Improved Technical Specifications

LaSalle County Station

Volume 13:
Unit 2 CTS Markup
In CTS Order

ComEd

Figure 3.1.6-1

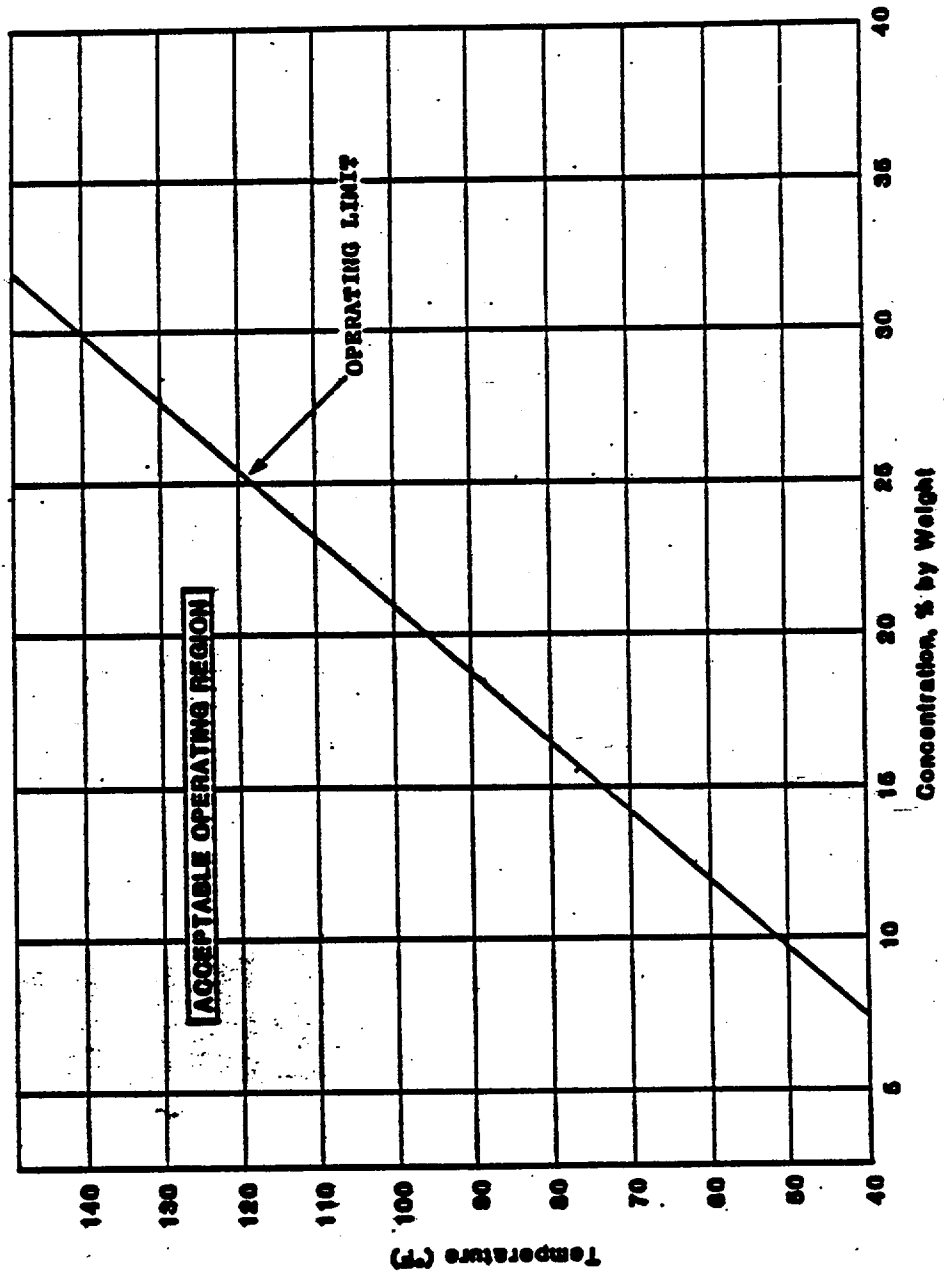
Figure 3.1.7-2

Figure 3.1.5-2

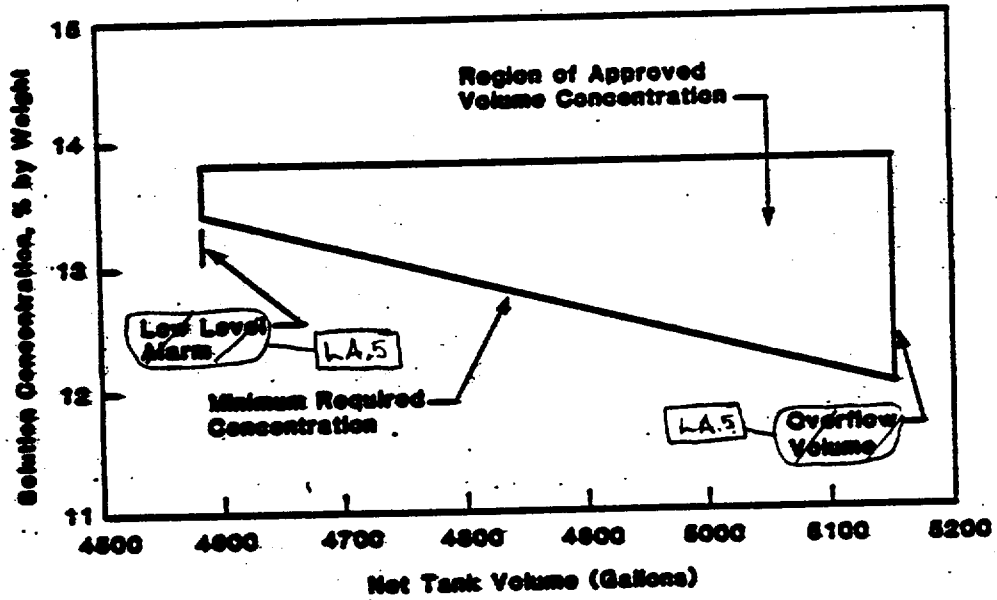
Figure 3.1.7-1

Figure 3.4.1-1 (Page 1 of 1)
Power versus Flow

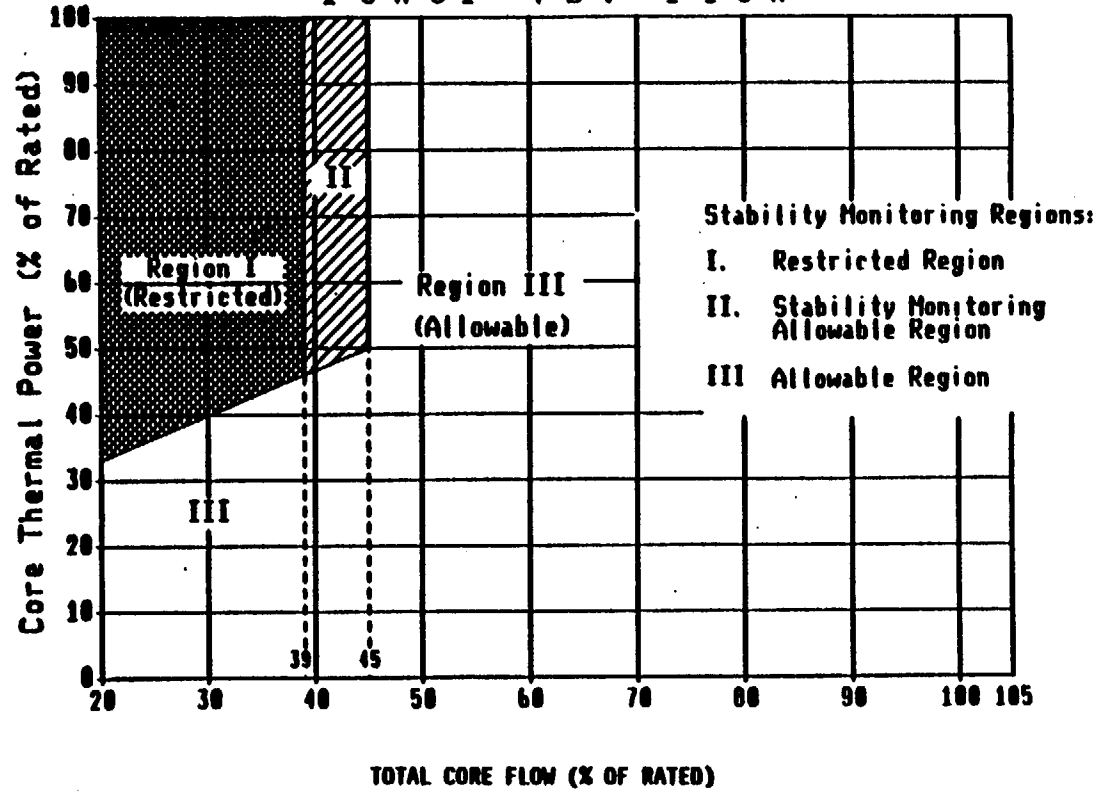
LA.5

SURVEILLANCE REQUIREMENTS

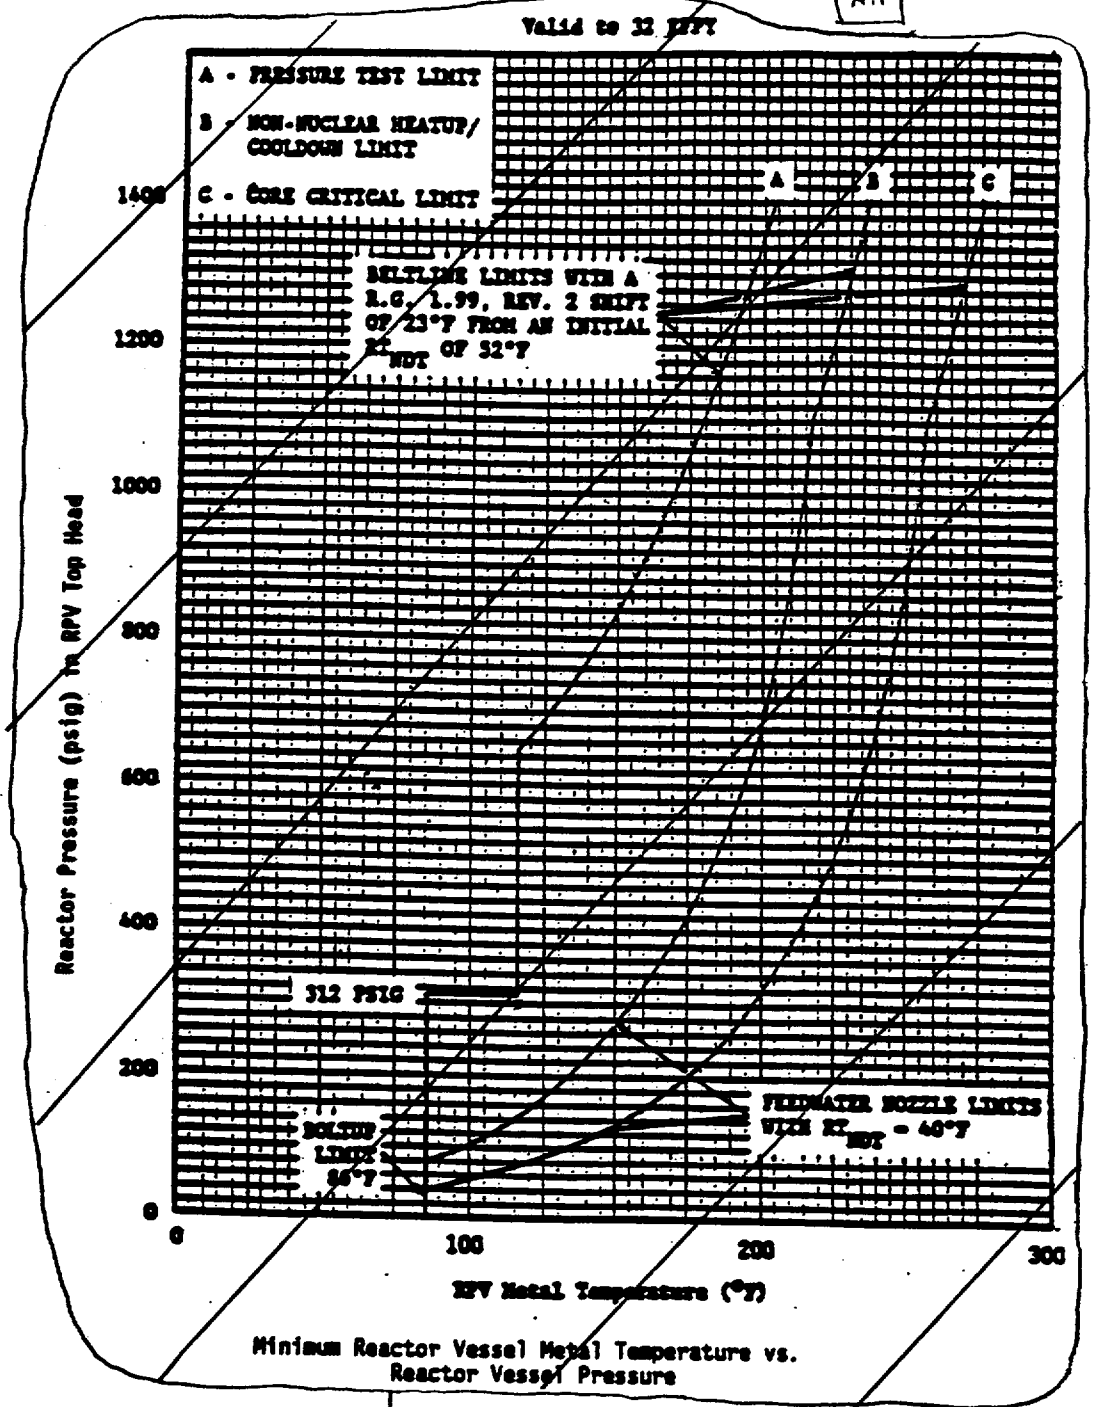
Note 1 to
Surveillance
Requirements
